**Duquesne Light**

Reference: Beaver Valley Power Station, Unit No. 1  
Docket No. 50-334, License No. DPR-66  
NUREG-0737, Item II.F.2, ICC Instrumentation System

### Response to NRC Request for Information dated November 12, 1986 on Inadequate Core Cooling Instrumentation

VESSEL LEVEL PAGE 1 (WITH RCP(S) ON)

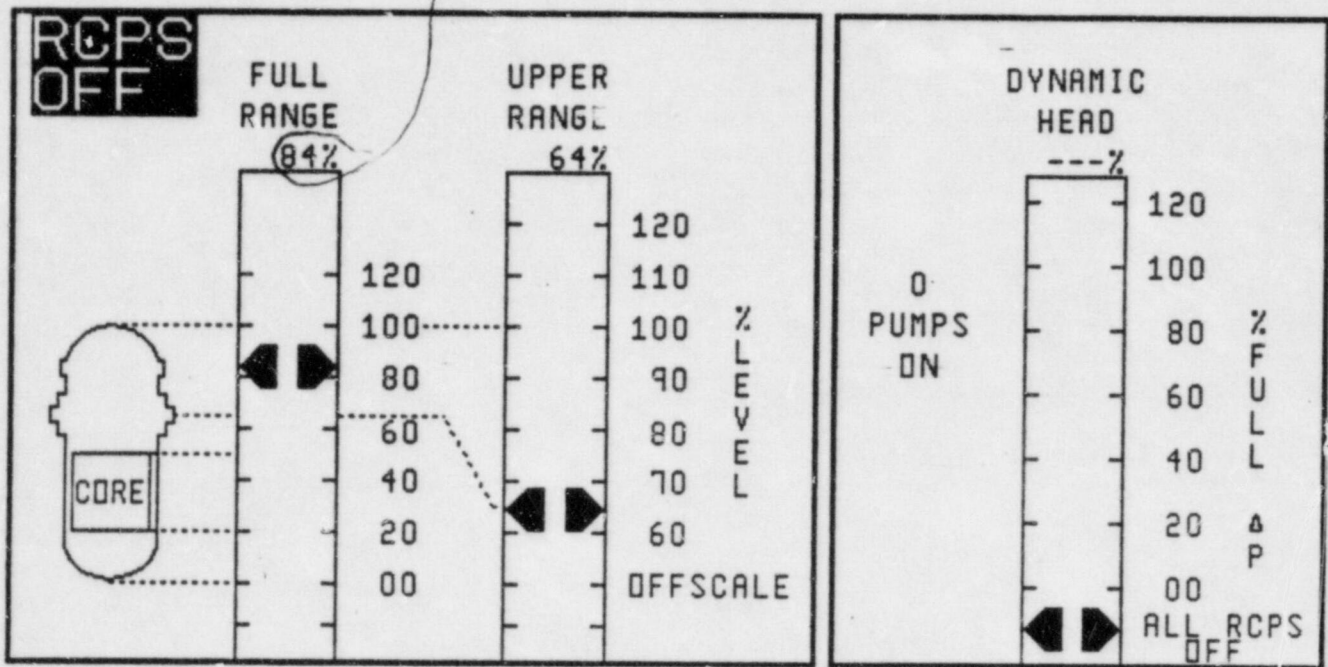
Reverse Video when  $\leq 40\%$   
and 5 HOTTEST T/C AVG  $\geq 700F$

P-T CURVE PAGE

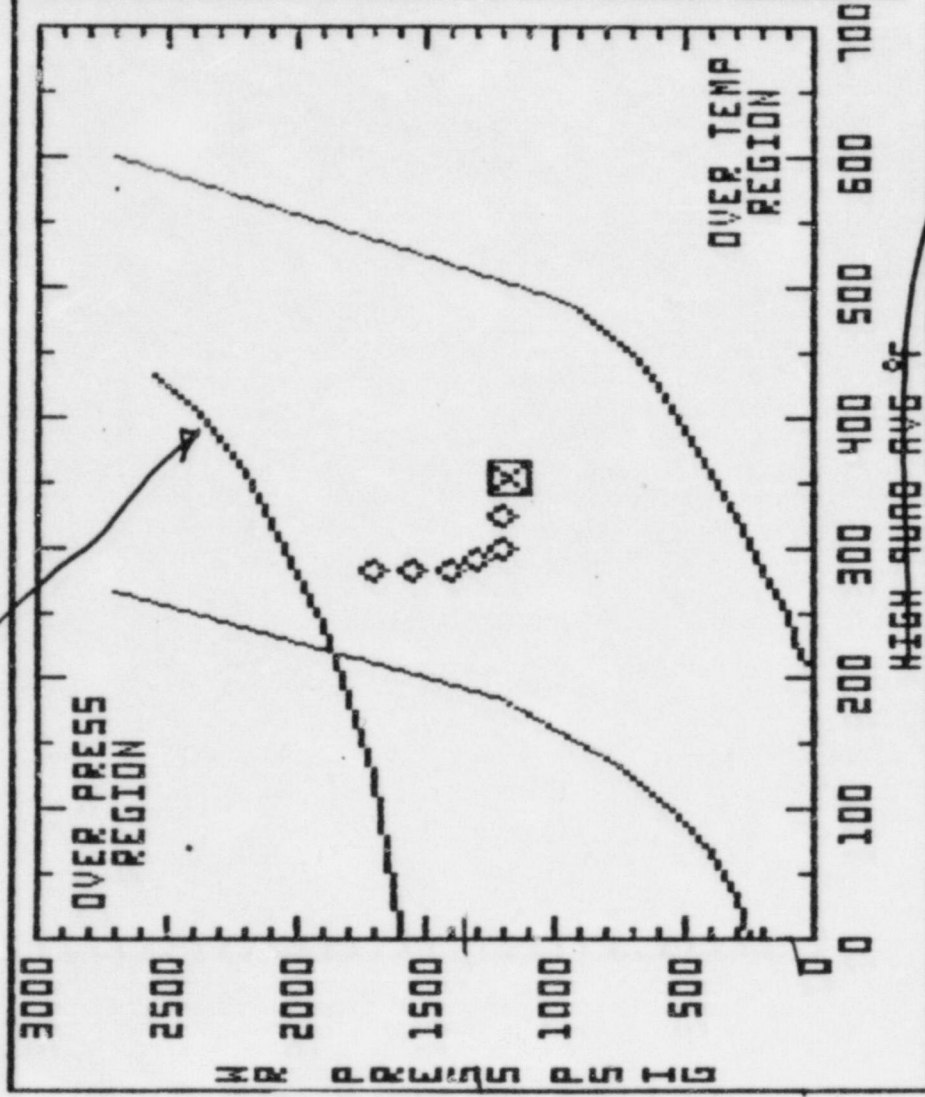
DELETE

ADD T/C

Reverse Video when > 1200

DELETE

CHANGE TO:

AVG 5 HIGH T/C OF

T/C PAGE 1

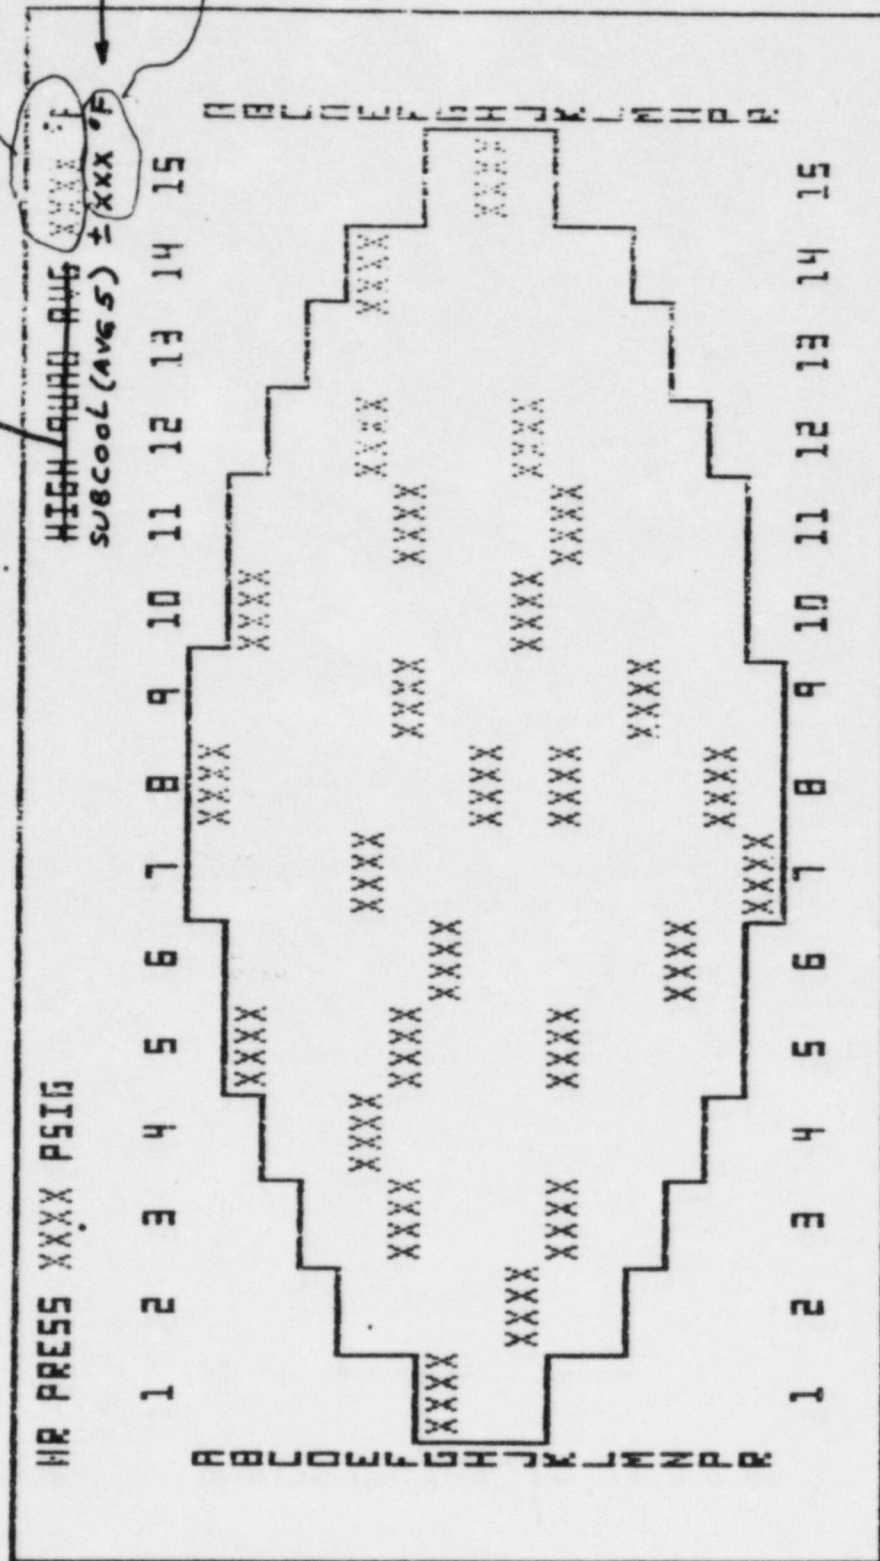
CHANGE TO:

AUG 5 HIGH T/C

Reverse Video 21200  
Reverse Video when in alarm

ADD

T/C QUADRANT SUMMARY PAGE

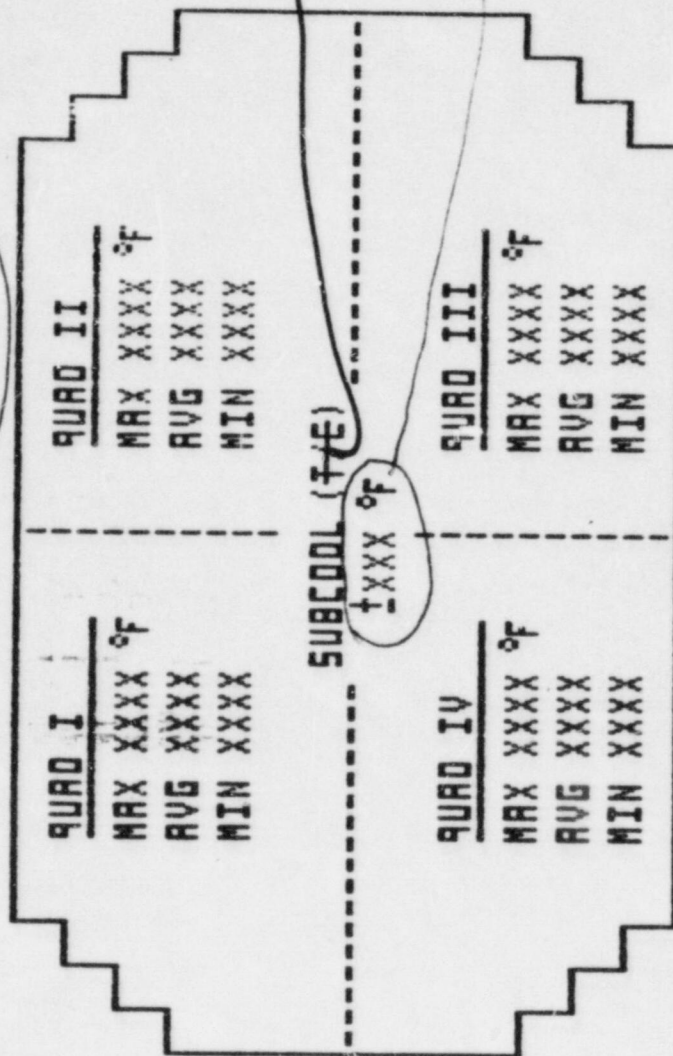
AVG 5 HIGH T/C XXXX °F Reverse Video ≥ 1200

-----  
THERMOCOUPLE DIAGNOSTIC PAGE 1

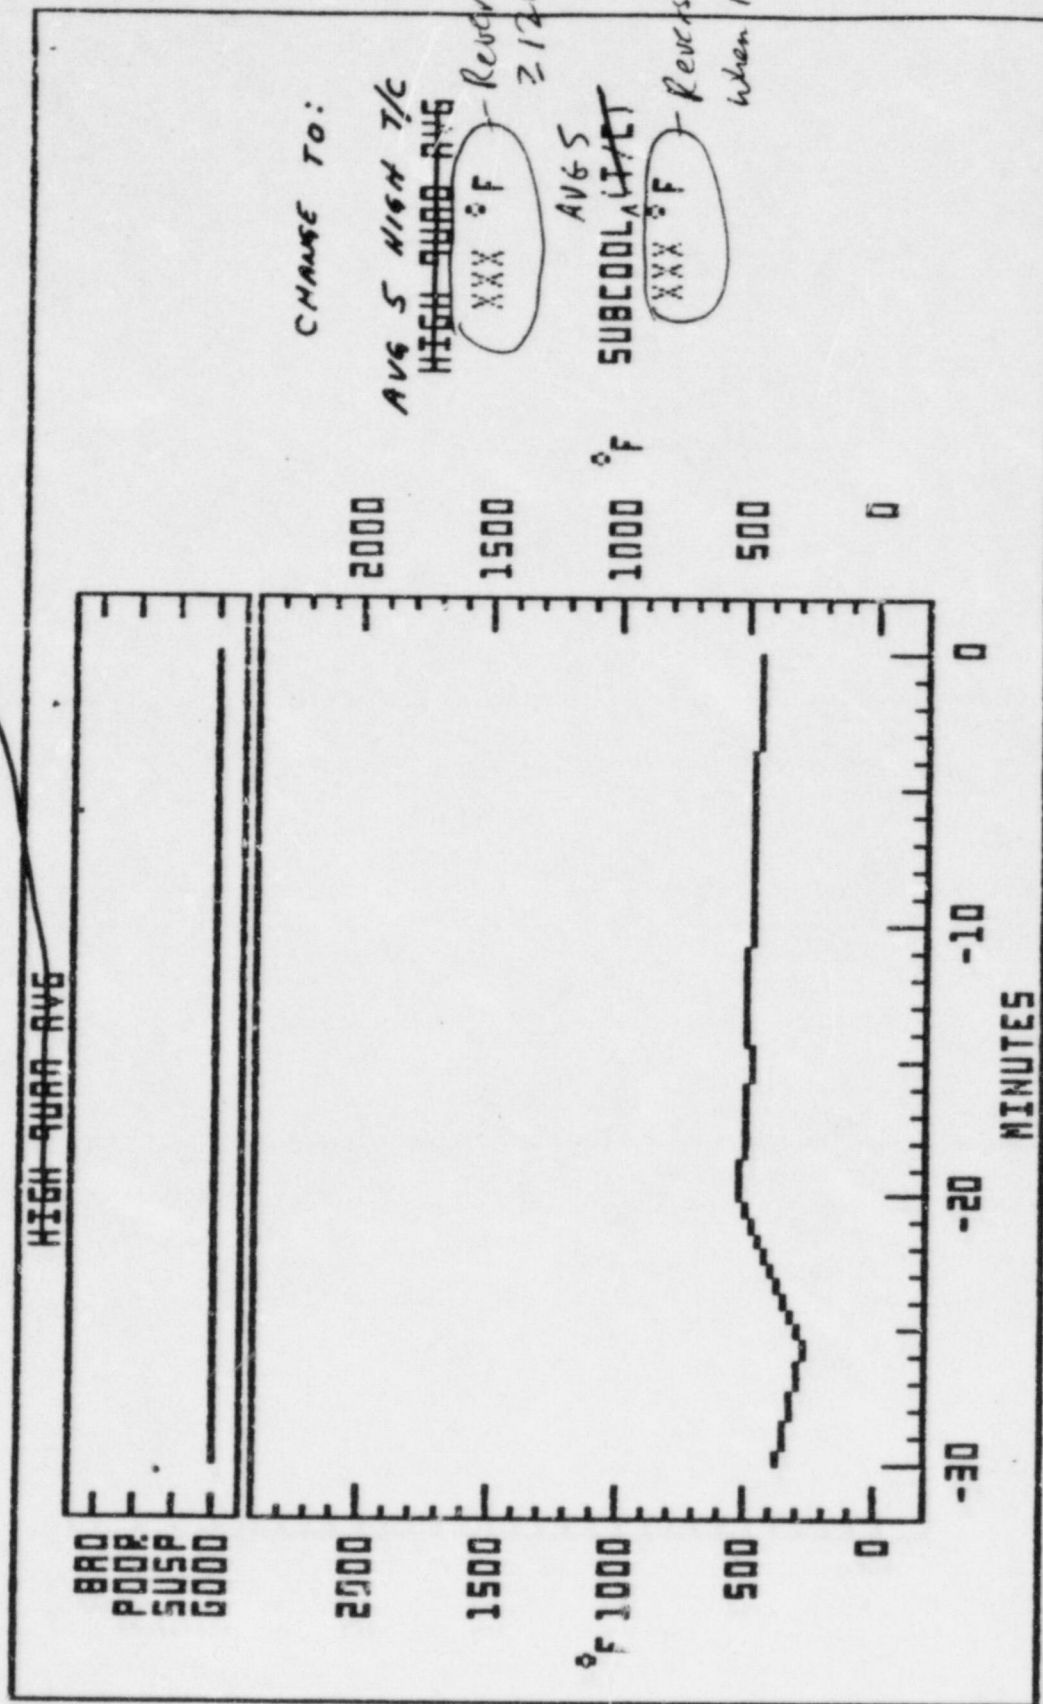
REVERSE VIDEO  
Z 1200

Delete

Delete

These set  
are hottest  
5 T/Cs

delete

FUNCTION  
Set for  
5 hottest T/Cs  
= 1200 F

FUNCTION  
Set for  
THOT RTD  
= 700 F

NOTE: Above setpoints are to be programmable
